UNITED STATES PATENT AND TRADEMARK OFFICE

APPLICATION NO.	FILING DATE	FIRST NAMED INVENTOR	ATTORNEY DOCKET NO.	CONFIRMATION NO.
09/803,412	03/09/2001	Harry W. Schmidt	T268.12-0047	4806
26285	7590	03/17/2005		
KIRKPATRICK & LOCKHART NICHOLSON GRAHAM LLP 535 SMITHFIELD STREET PITTSBURGH, PA 15222				
			EXAMINER CROSS, LATOYA I	
			ART UNIT 1743	PAPER NUMBER

Office Action Summary	Application No. 09/803,412	Applicant(s) SCHMIDT ET AL.	
	Examiner LaToya I. Cross	Art Unit 1743

DETAILED ACTION

Figure 3 (partial) of instant invention

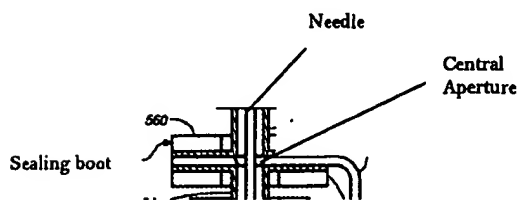
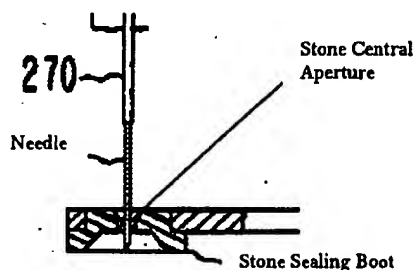
It appears that Applicants rely on their sealing boot (558) in combination with needle block (574) to support their claim of a "seal". However, the needle block feature is not a part of the instant claims. The Examiner understands Applicants' argument that according to the disclosure of Stone and figure 4 of Stone, the vial stabilizer (320) never reaches needle housing (280). However, the needle housing of Stone would be equivalent to the needle block of the instant invention, which is not claimed.

Furthermore, according to the specification, Applicants' sealing boot is depicted by reference character (558), which is shown as a structure disposed about the sampling needle and having a central aperture through which the needle may move. Stone shows the same structure surrounding the sampling needle and having a central aperture through which the needle may

move. Thus, although Stone may not disclose the vial stabilizer as a "sealing boot", the structures are the same.
